PCN No#: 052021-1

PCN Title: MCC will add new wafer source for ESDLC0524DFN10-TP

PRODUCT CHANGE NOTICE

Table A - Marking code comparison

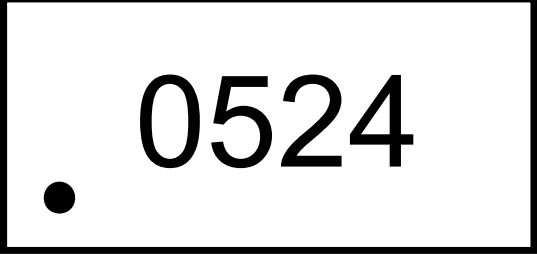
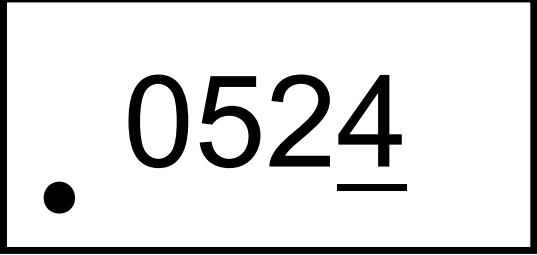
Notification Date	Implementation Date	Last Time Buy Ship Date	Change Type	PCN No
May 20, 2021	ASAP	N/A	Add new wafer source	052021-1
TITLE				
MCC will add new wafer source for ESDLC0524DFN10-TP				
DESCRIPTION OF CHANGE				
To solve our delivery issue of ESDLC0524DFN10-TP, MCC has determined to add a new wafer source. Internal qualification process had been finished and the result showed that the parts with new wafer exactly met our specification.				
IMPACT				
No change in datasheet electrical parameters . Table A: Marking code comparison. Table B: Electrical characteristics comparison.				
PRODUCTS AFFECTED				
ESDLC0524DFN10-TP				
WEB LINKS				
Terms And Conditions:	https://www.mccsemi.com/Home/TermsAndConditions			
For More Information Contact:	https://www.mccsemi.com/Contact/Index			
Products:	https://www.mccsemi.com/ProductCategories			
DISCLAIMER				
Unless a MCC Sales representative is contacted in writing within 30 days of the posting of this notice, all changes described in this announcement are considered approved.
